General Bid Bulletin No. 32
01 October 2021

**THE MALOLOS-CLARK RAILWAY PROJECT AND THE NORTH-SOUTH RAILWAY
PROJECT SOUTH LINE COMMUTER PACKAGE CP NS-01: PROCUREMENT OF
ELECTRICAL AND MECHANICAL SYSTEMS AND TRACK WORKS (IFB No: 21-040-3)**

This General Bid Bulletin is issued to amend/clarify certain provisions in the Bidding Documents for the above-mentioned Project. Please refer to the attached Annexes of this General Bid Bulletin for details:

DATE	MAY 2019
SCALE	AS SHOWN IN A1
SHEET No.	
DRG No.	MCRP-DWG-GEN-TK-0206
DRG S.	REV 04

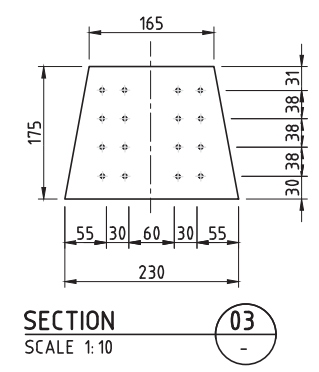
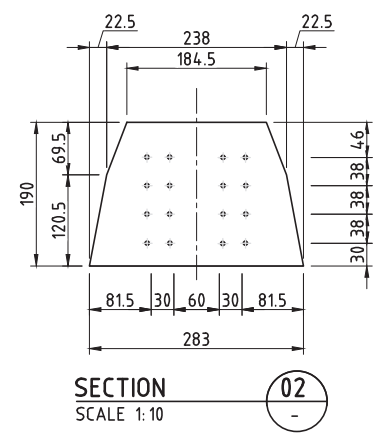
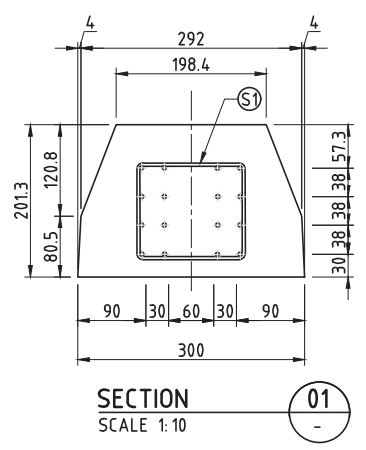
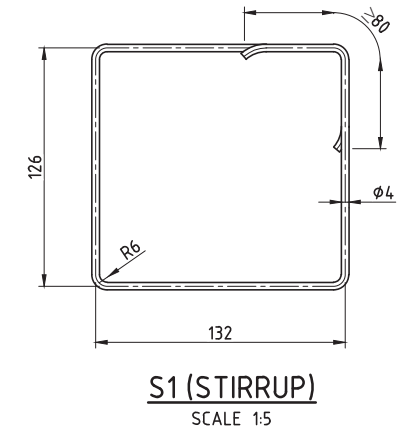
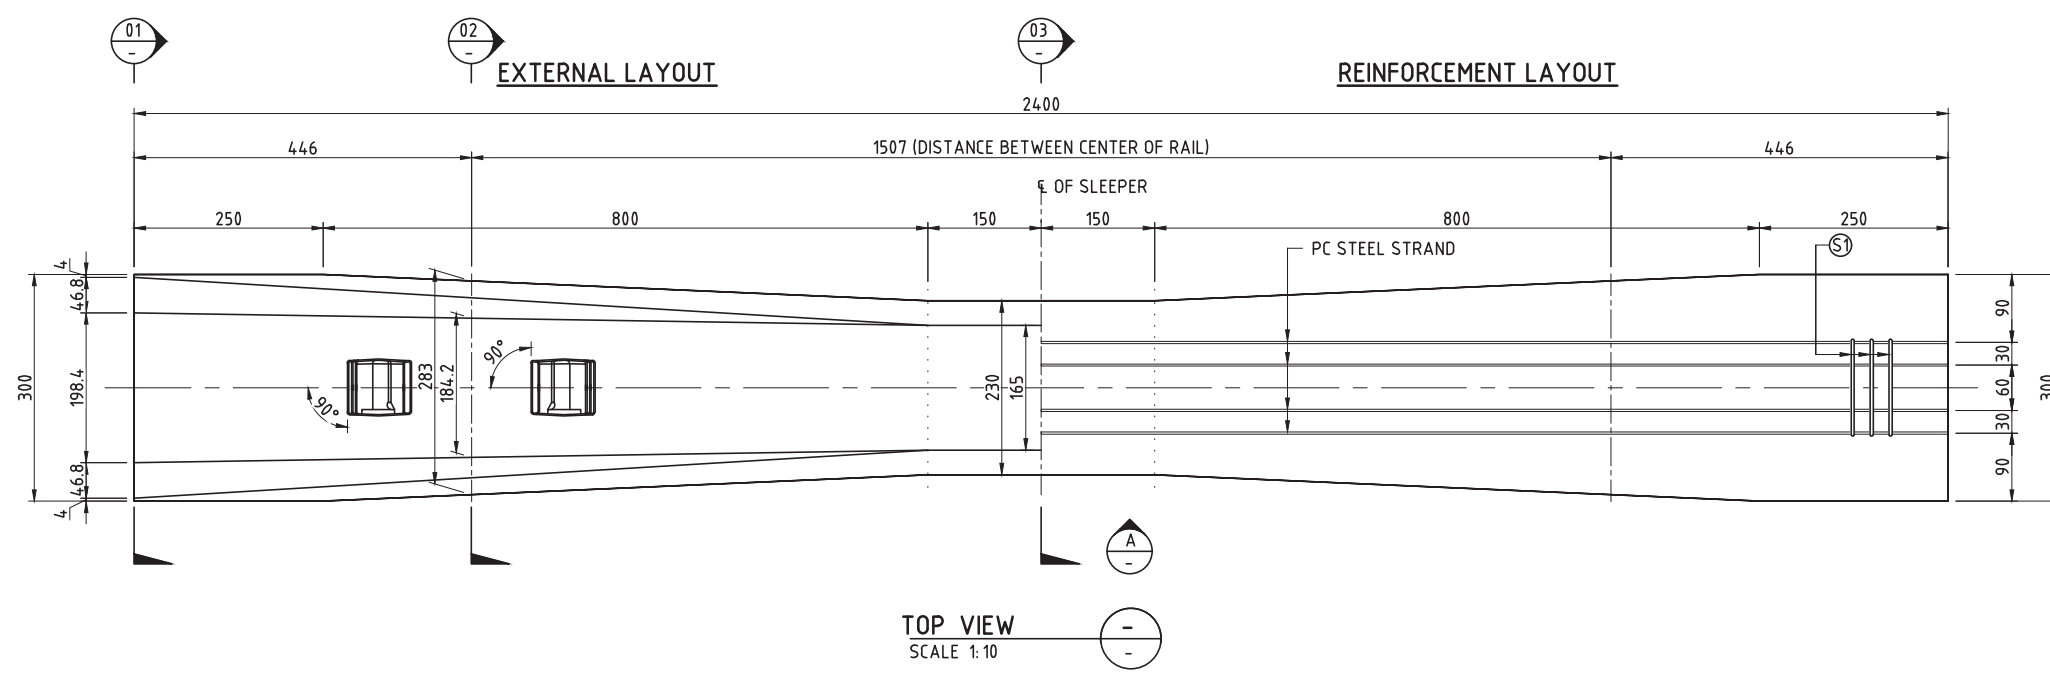
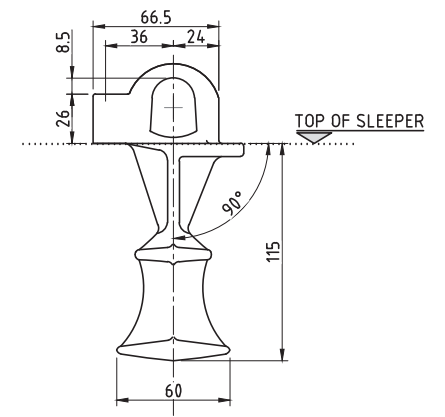
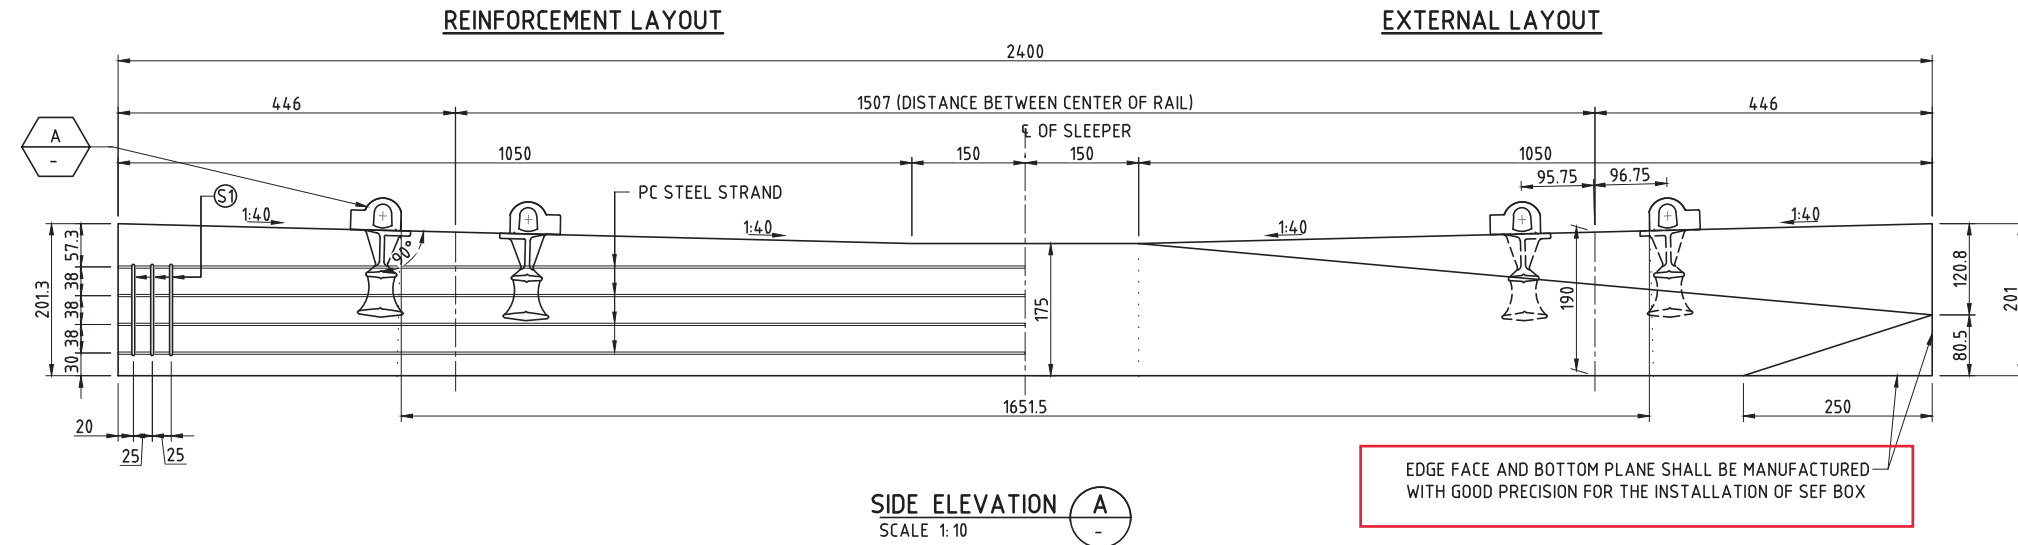
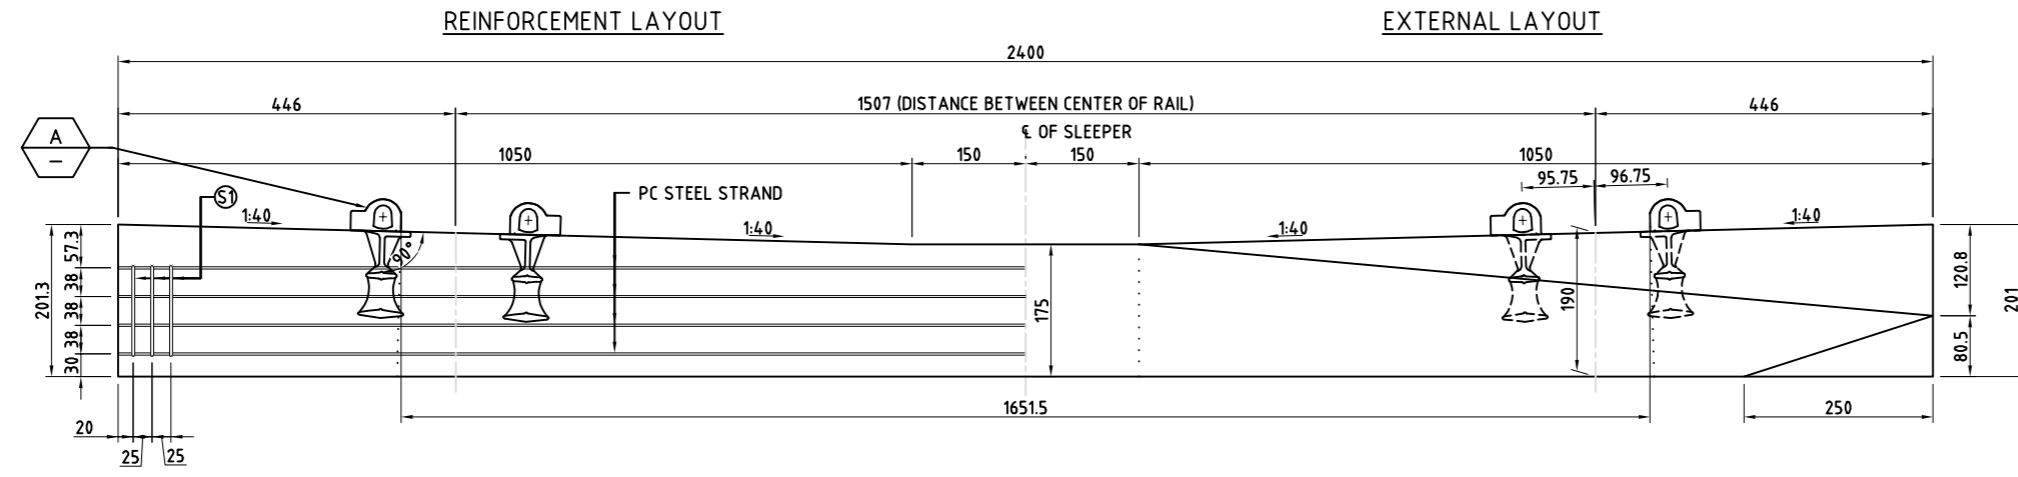
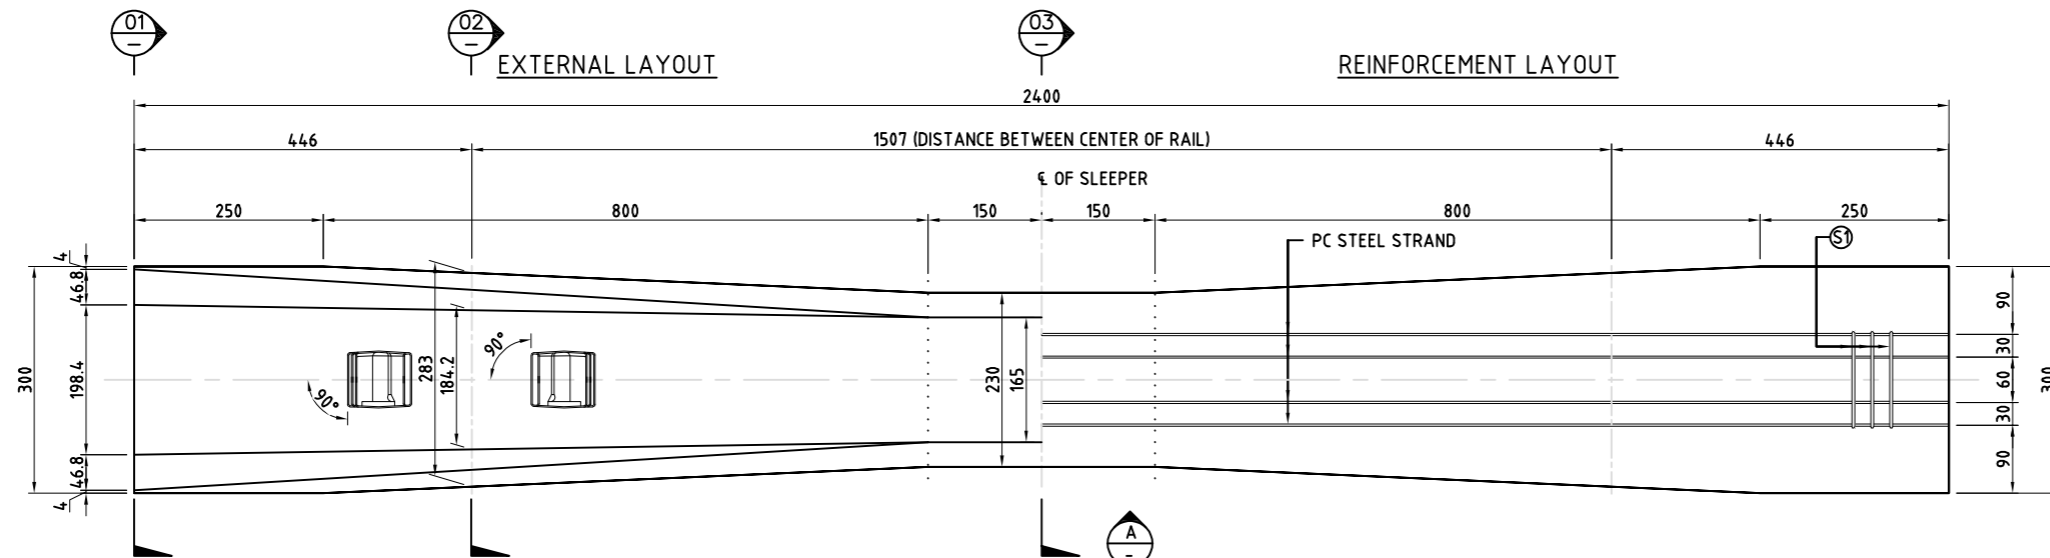
Item No.	Volume Section No. Page No. Clause No. / Title Reference Text	Clarification Request	Proposed Revised Text (if any)	Response
27	Part -2 Section VI Employer's Drawings, 59/321, MCRP-DWG-GEN-TK-0206, TYPICAL DETAILS FOR MONO-BLOCK PSC CONCRETE SLEEPER FOR BALLASTED TRACK 	In the referred drawing, there is a note written as "Edge face and bottom plane shall be manufactured with good precision for the installation of SEF box". We understand from the tender specifications that there is no requirement of any SEF box or Elastic mats for the PSC Sleepers for the Depot Ballasted Track. We also understand that the referred note from the drawing has no significance. Kindly confirm our understanding.		The Bidder's understanding is correct. Please refer to Annex B for the revised reference drawing.
28	Part -2 Section VI, ERT-47, 1.23 Walkway,	We understand from the referred clause that the bidder shall design the Walkway complying to the tender conditions. We also understand that the Walkway can rest on the Viaduct Parapet wall, or the bidder can design Walkway in such a way that it will be supported on the Viaduct parapet wall. Kindly confirm.		The Bidder's understanding is incorrect. The walkway shall be separate from the parapet wall and not impose any load on the parapet.

Volume III Part 2 – Employer’s Requirements d) Employer’s Drawings		
28	Volume III Part 2- Employers Requirements Drawings (a)	Drawing MCRP-DWG-GEN-TK-0206 REV. 03 has been revised to drawing MCRP-DWG-GEN-TK-0206 REV. 04
29	Volume III Part 2- Employers Requirements Drawings (a)	Drawing MCRP-DWG-GEN-TK-0117 REV. 03 has been revised to drawing MCRP-DWG-GEN-TK-0117 REV. 04
